Release Note KL-3T **VA1** v2.11.27.68

(This version is only compatible with the new HW version – VA1)

Device Hardware Version

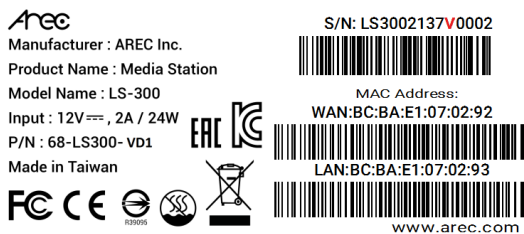
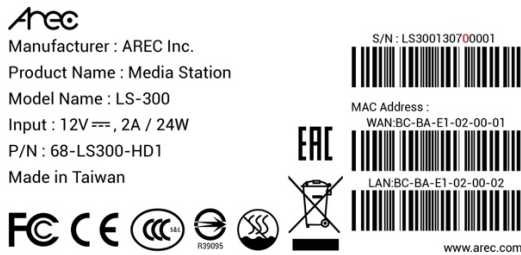
1. Please find your device serial number (S/N), it can be found either on the label or on the web Administration page.

2. Check the 10<sup>th</sup> digit of the S/N. If it is “V”, then the device has the new hardware. If it is “0”, it has the original hardware and is not compatible with the firmware series described in this release note.

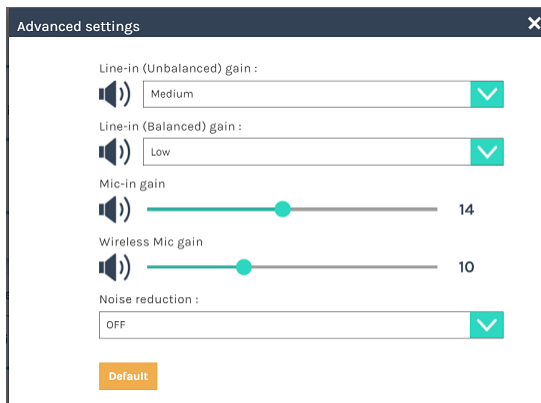
1. Differential audio input with phoenix type connector is “only” available on **LS-300**, **LS-400** and **KL-3T**.
2. Audio Noise Reduction (Line-in/Mic-in)  
It can reduce the background noise that is present in recordings.
3. Audio Gain Control (Line-in/Mic-in)  
Both balanced (Phoenix) and unbalanced (3.5mm) audio inputs have “Gain Control”.
  - Line-in (Unbalanced/Balanced): 3-step gain – Low, Medium, High
  - Mic-in/BT-Mic: 30-step gain

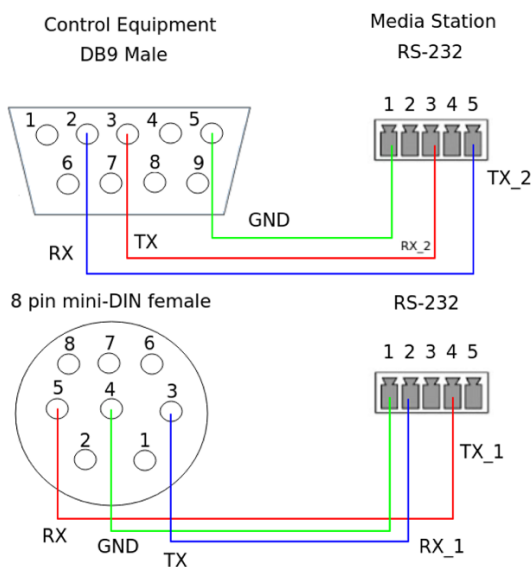
4. Equipped with one RE-232 camera control port  
The same RS-232 port can now send commands for camera control while receiving commands from control systems.  
\* It can only control one camera, for additional cameras, USB-RS-232 cables will still be needed.
